ADDENDUM

RFB NO. 322027 - ADDENDUM NO. 4

WINDOWS REPLACEMENT

**PROJECT: WINDOW REPLACEMENT
CITY-COUNTY BUILDING**

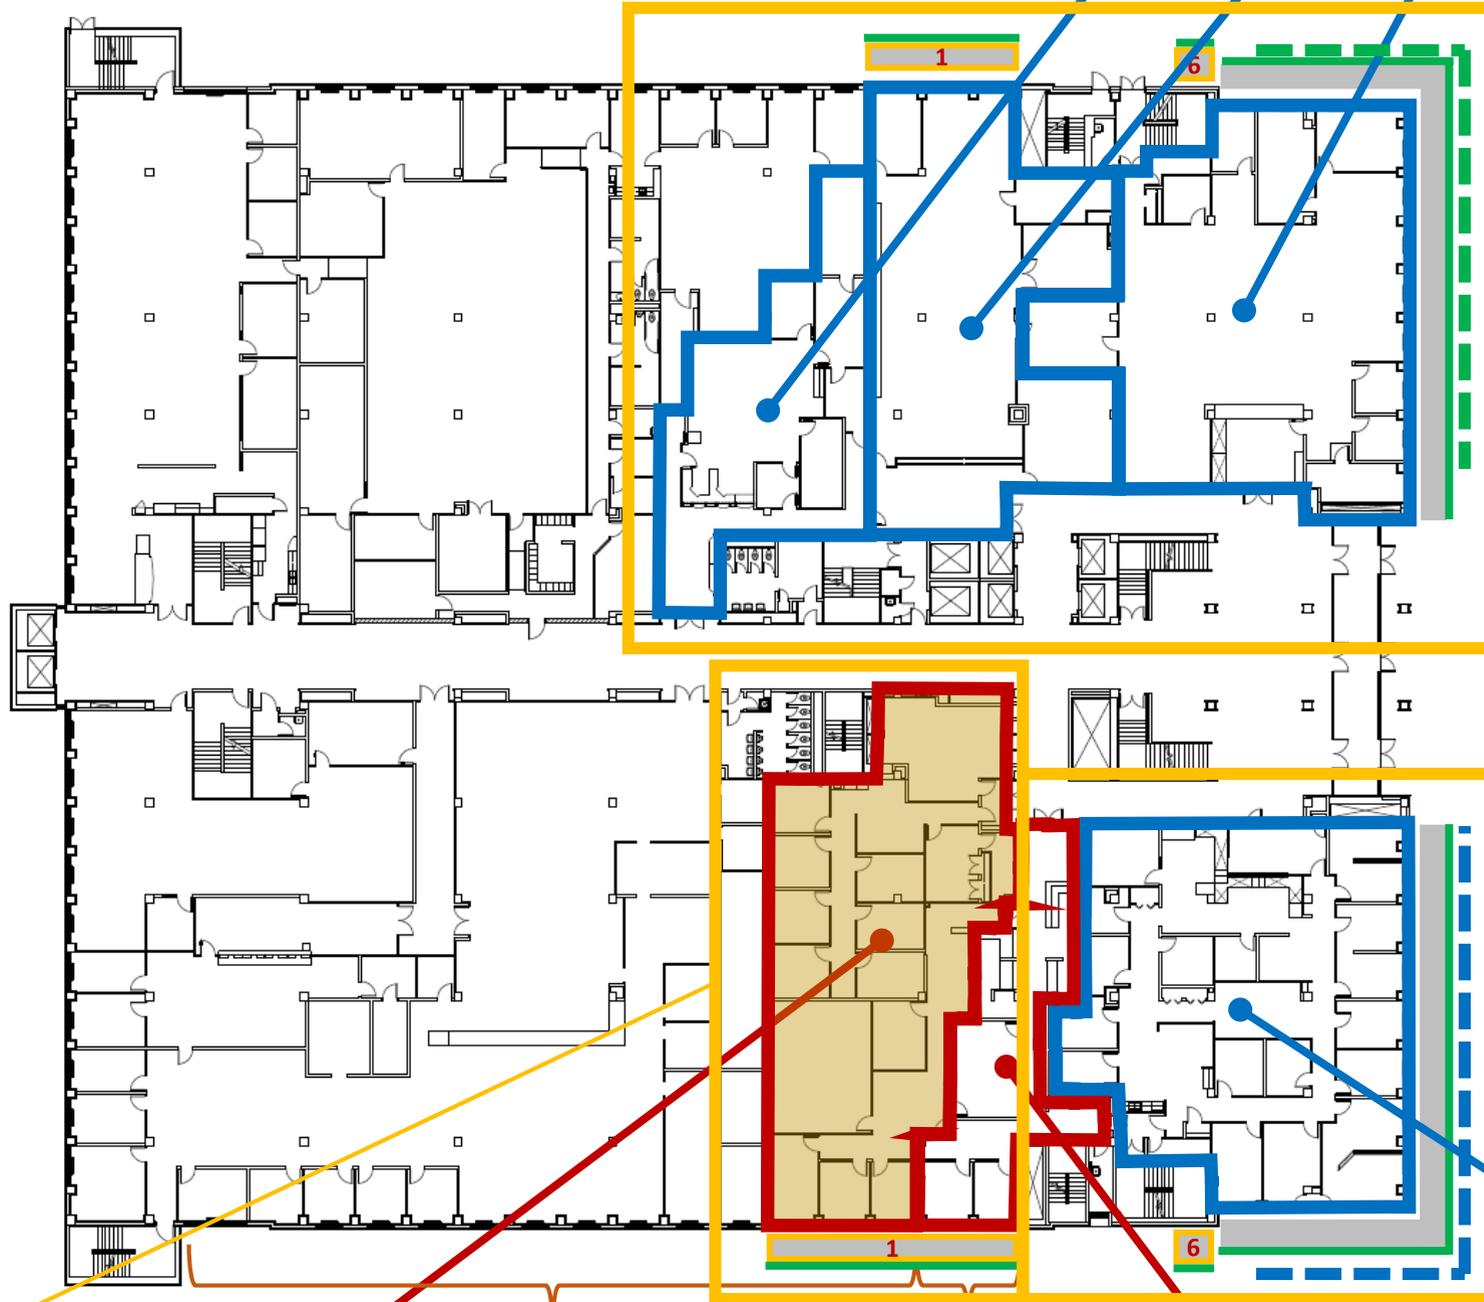
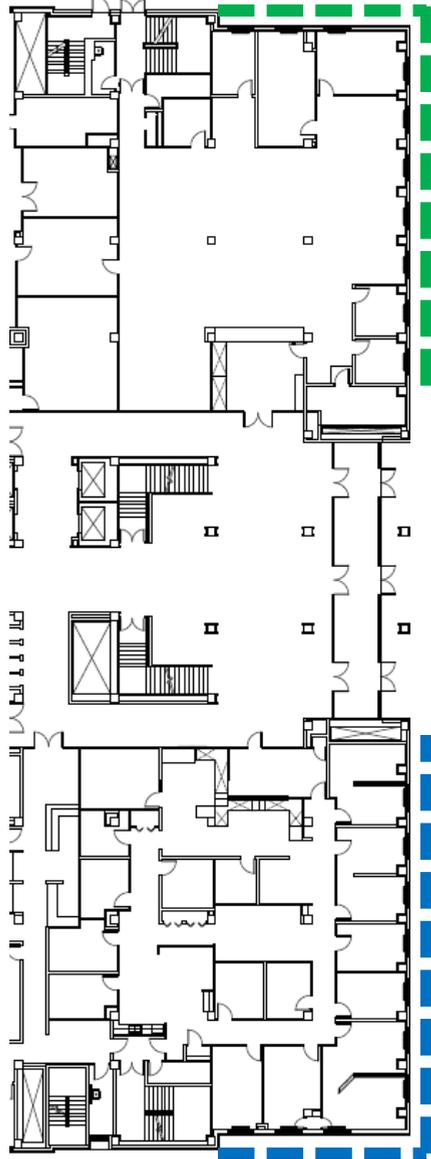
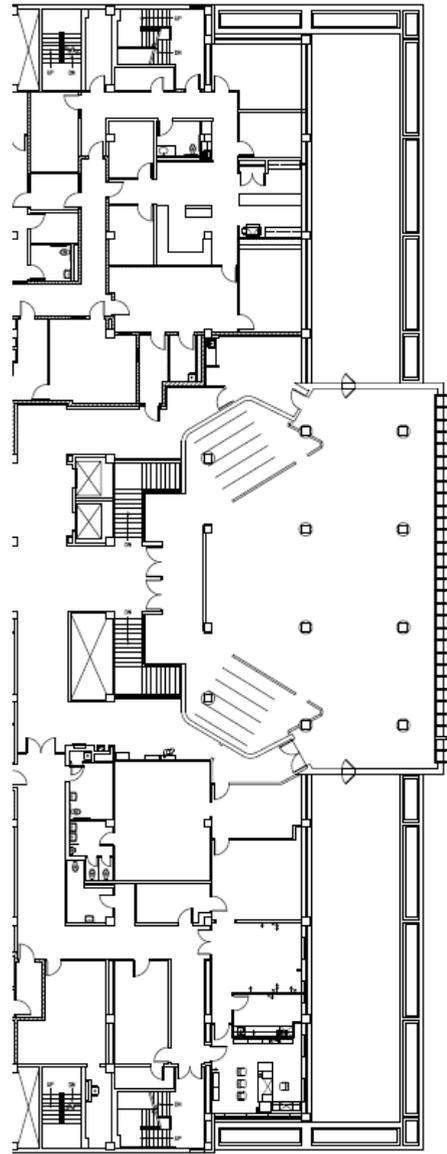
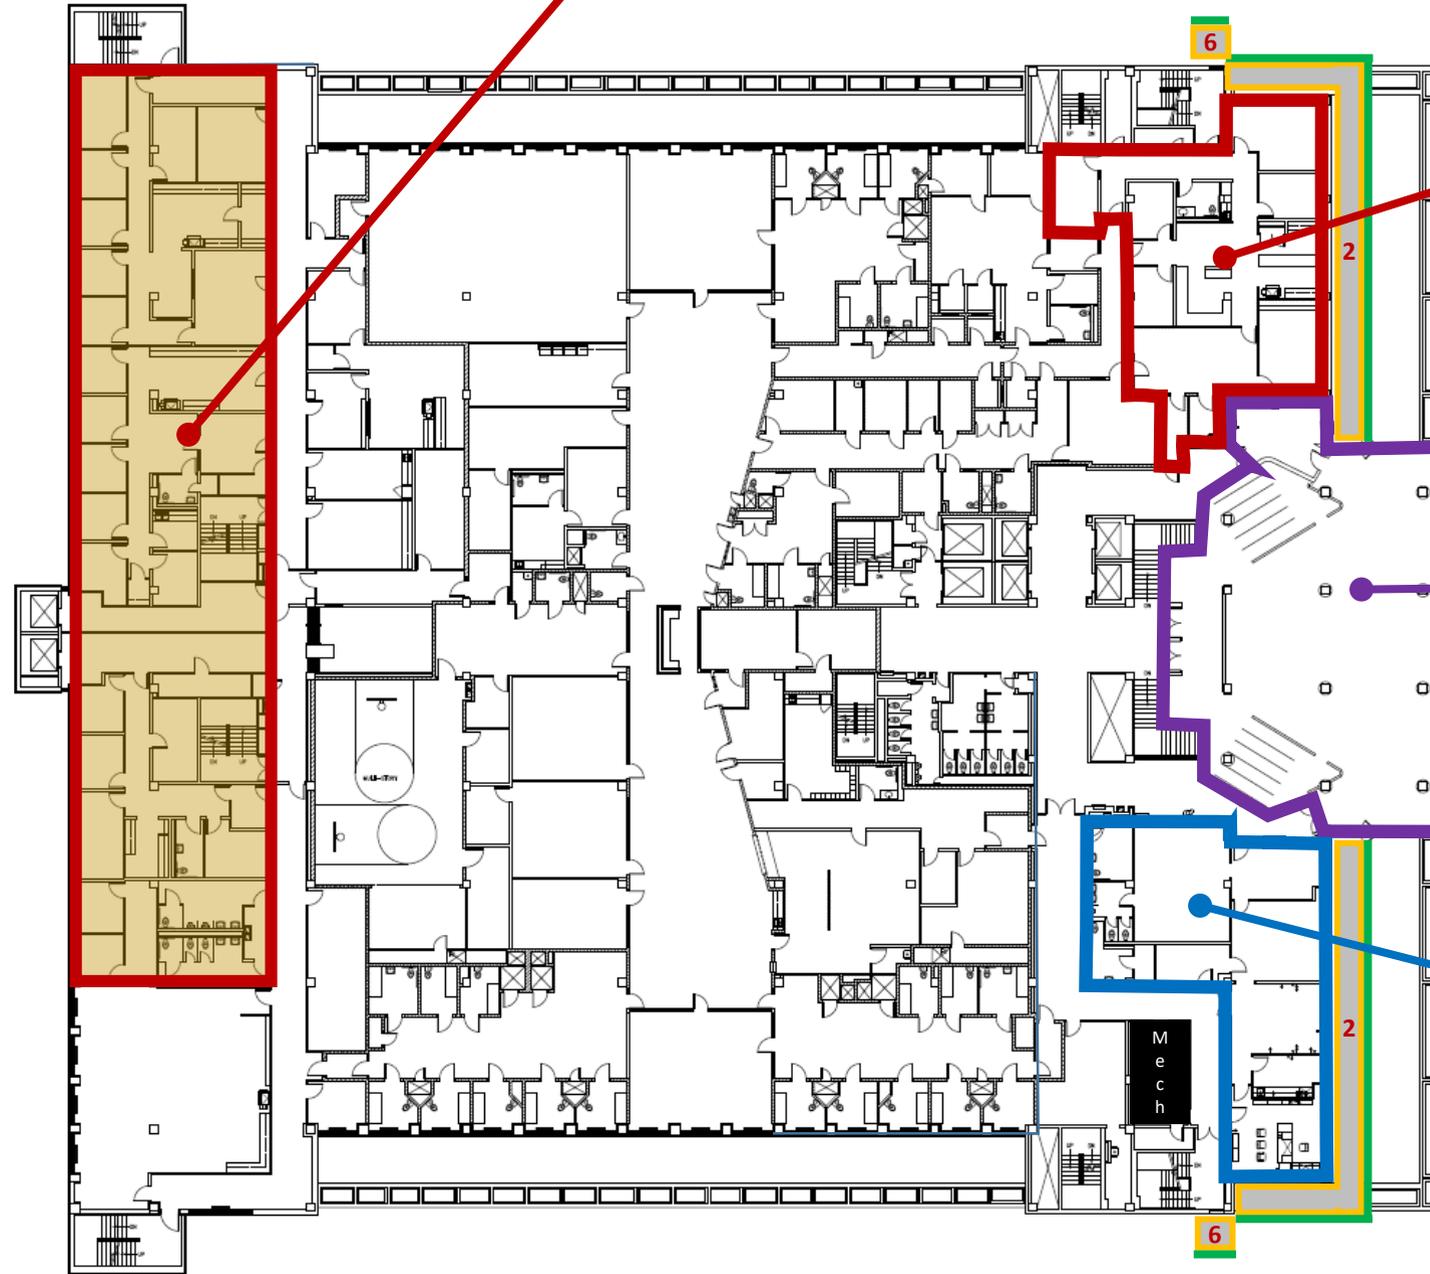
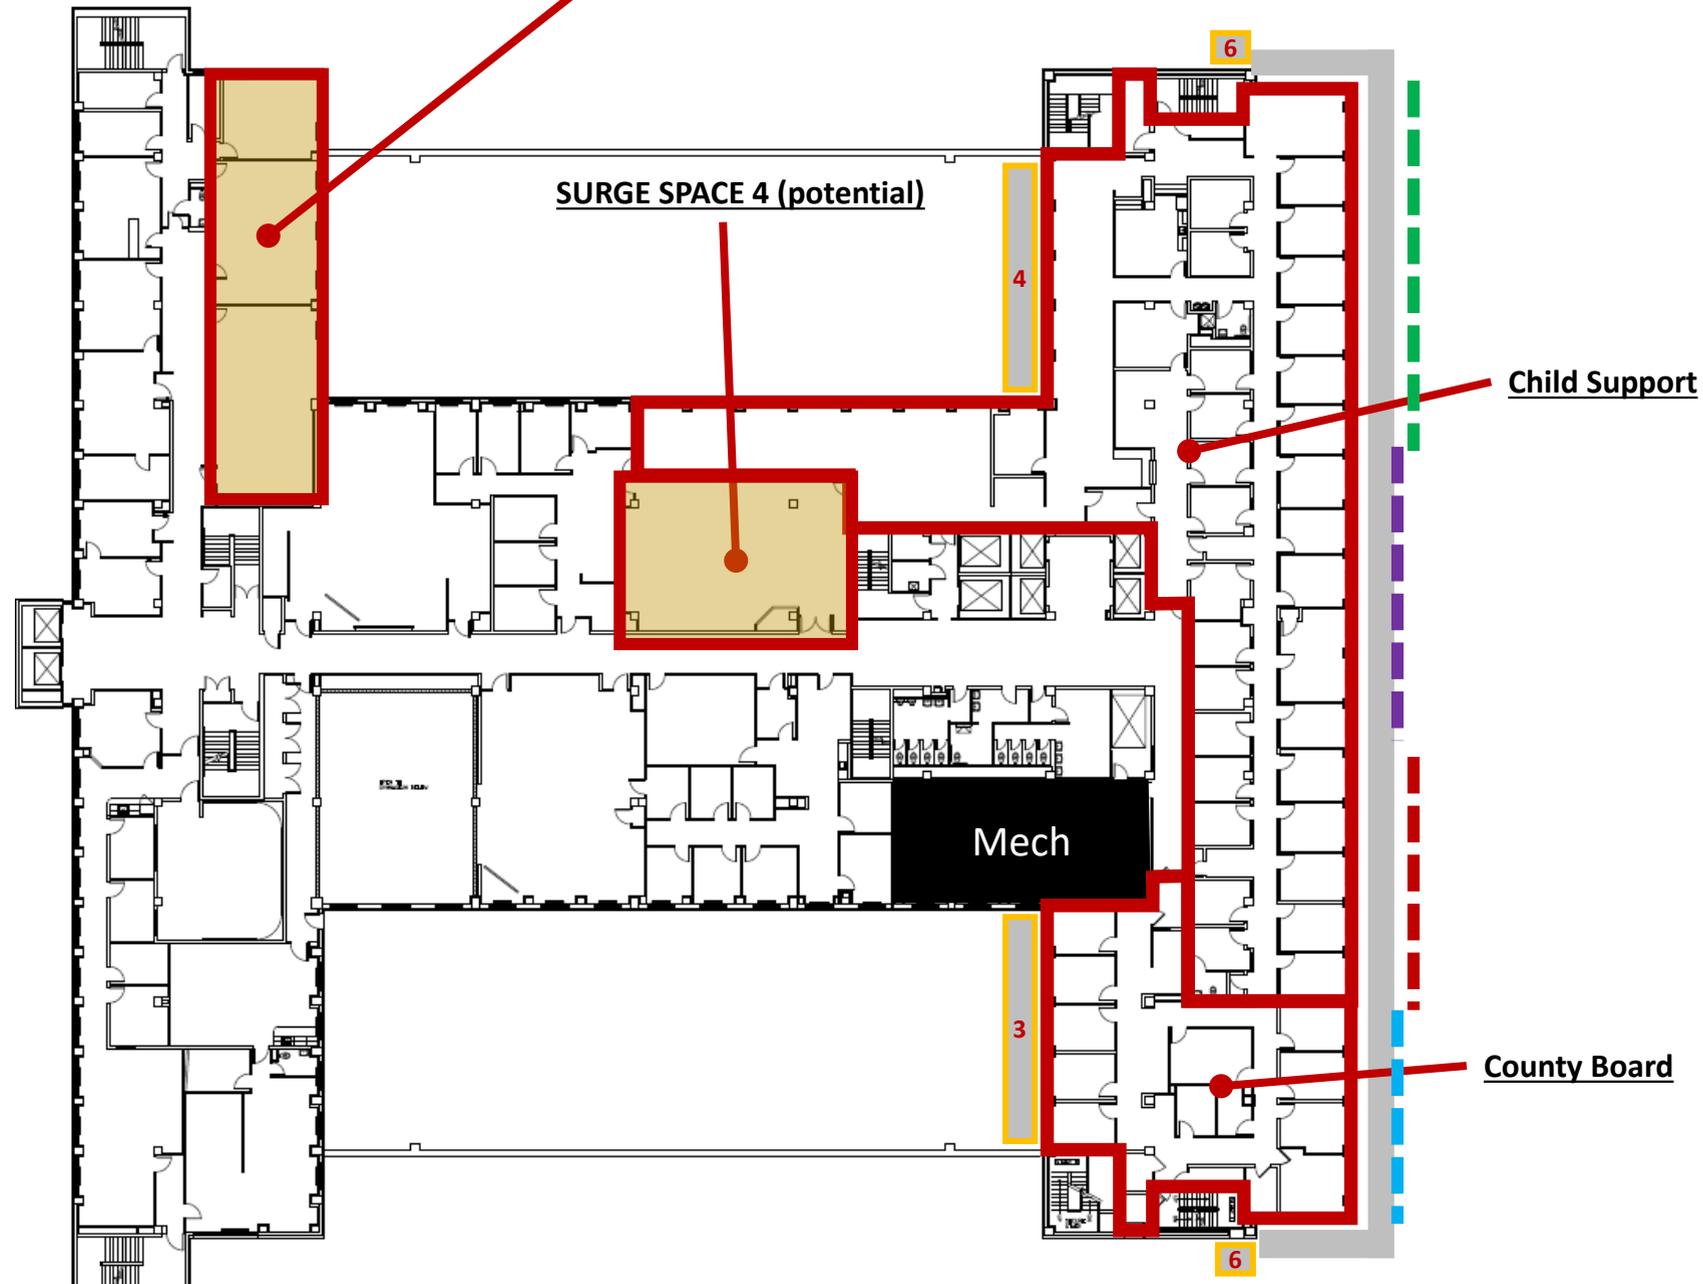
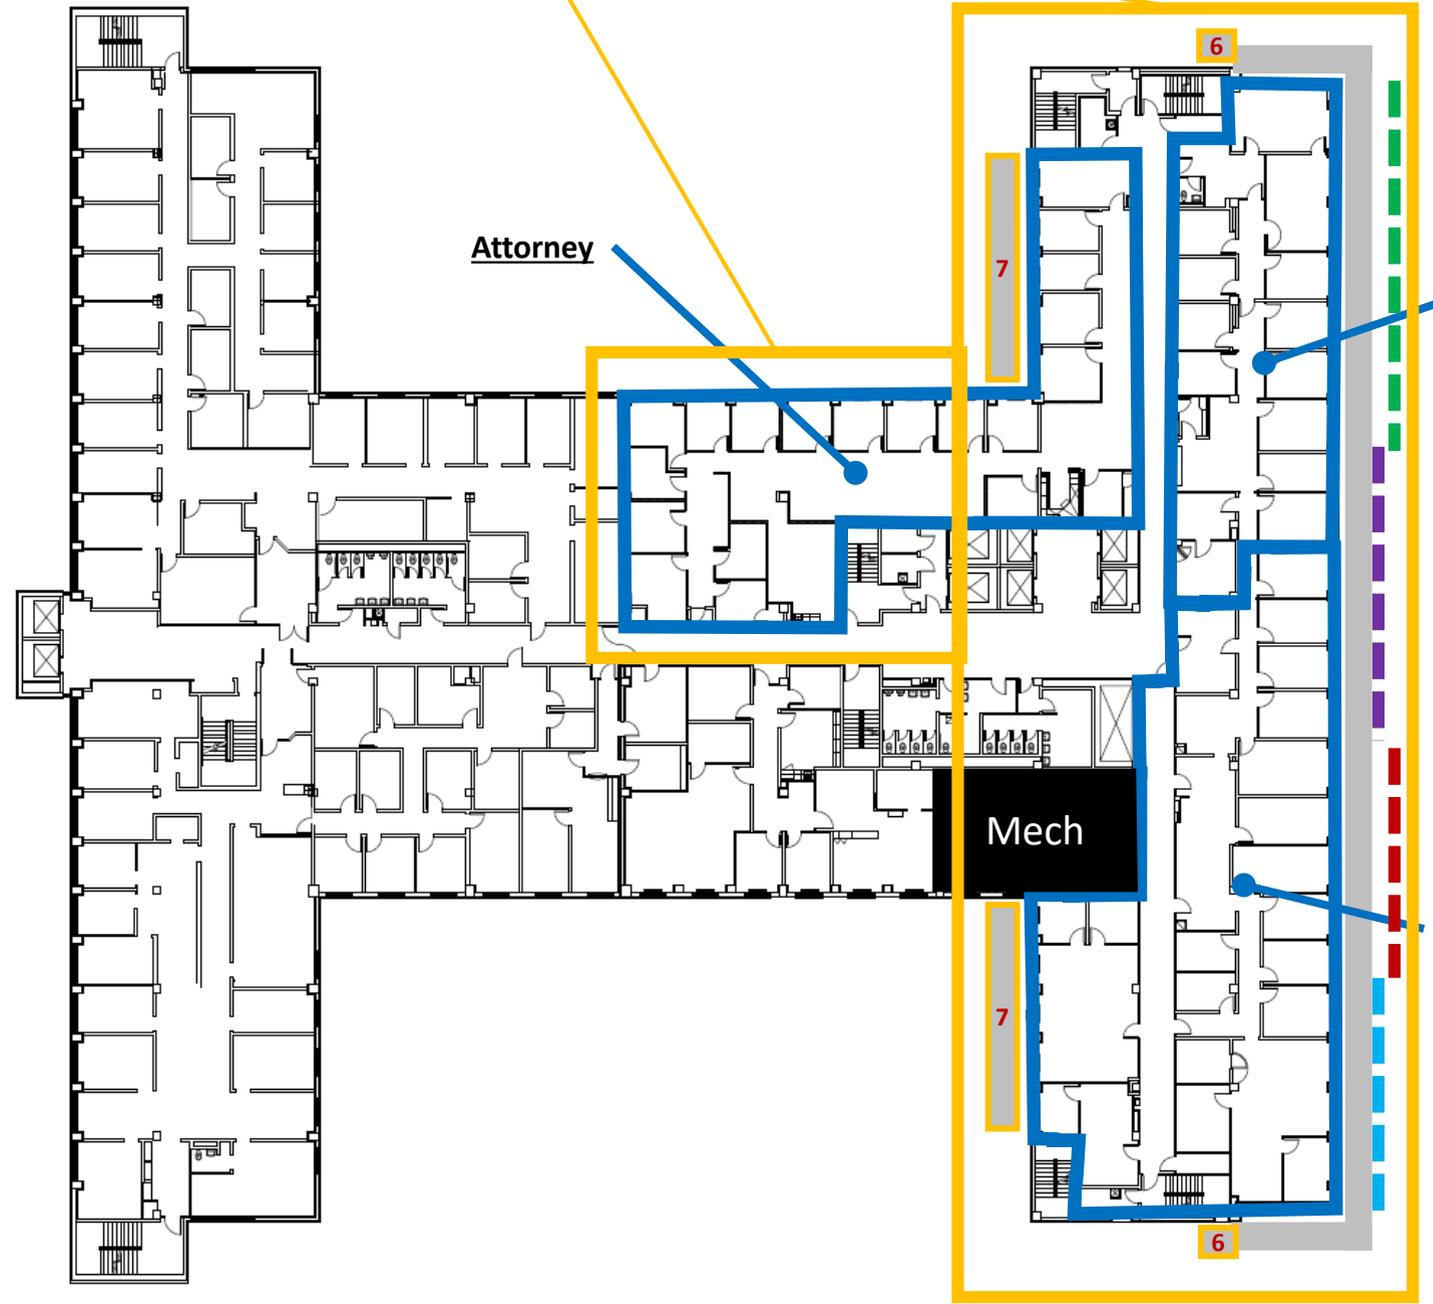
“H. Refer to Figures 1 - 7 for Base Bid work sequence & phasing. Alternate Bids work sequence & phasing shall be worked out with Contractor before any work commences.”
